Structural Engineer  
Signed and Stamped Letters in  
Response to Test Pit Investigation

RE: Paragon Paint and Varnish Co.  
Site Remedial Action  
45-40 Vernon Boulevard, Queens, NY.

DESCRIPTION VIEW OF GARAGE UST EXCAVATION W/ FOOTING TEST PITS

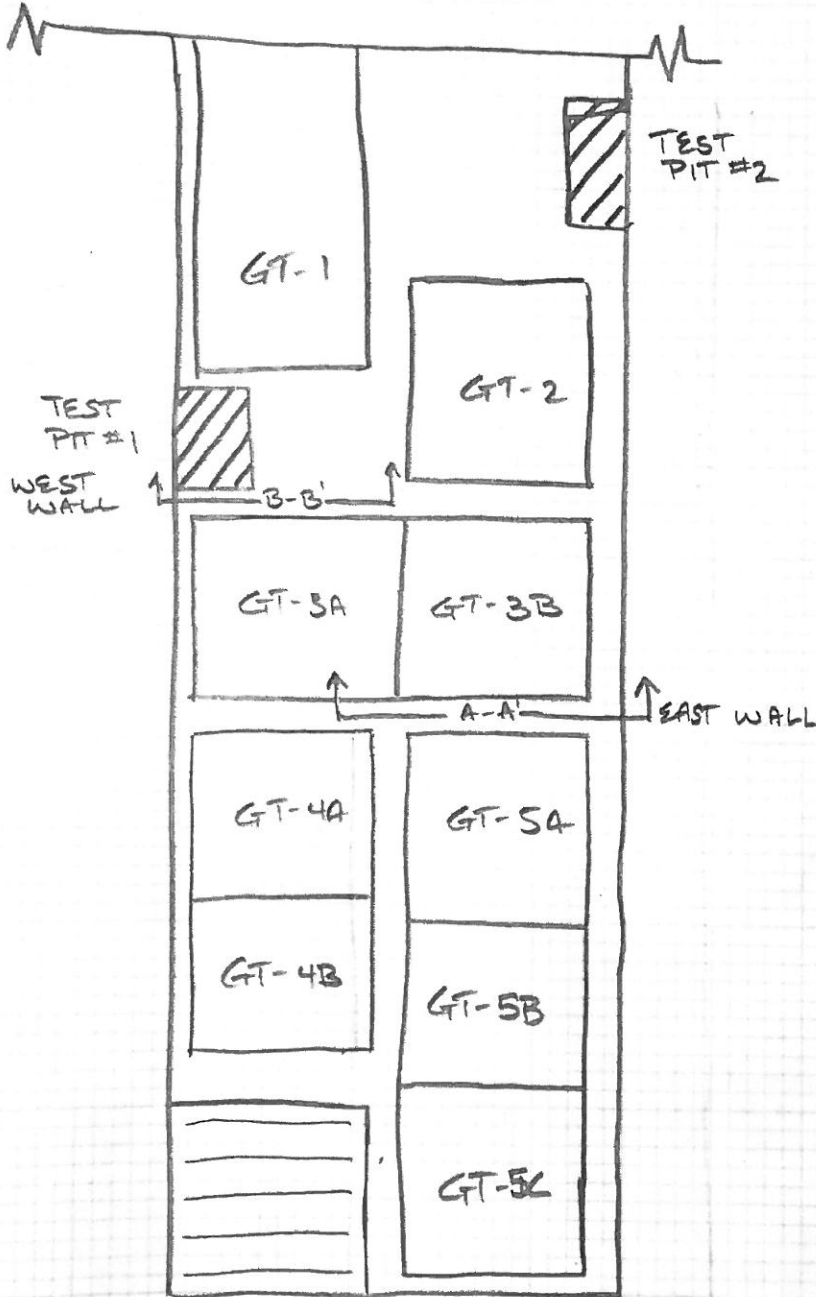
Sketches 1, 2 and 3, dated October 26, 2015 (attached) show a plan and sections through these tanks. The original plan for this portion of the project was to remove these tanks and backfill the site.

Due to the very close proximity of these large tanks to the foundation walls, and to the fact that they extend deeper than these walls, and that the groundwater level lies well above the bottom of these tanks, sheeting and underpinning of these walls cannot be done in a safe manner. There is literally no space for workers to excavate along these walls. The structural stability of the existing building would be compromised. Excavation by mechanical means would also prove to be unsafe, as even small excavations and other construction equipment can collapse these tanks, causing spillage of the liquid chemicals into the ground.

It is therefore strongly recommended that these tanks remain in place, be cleaned of all chemicals, and filled with clean sand, RCA or flowable fill. A gravel layer can then be placed over the tanks, and a new concrete slab can be placed over the gravel.
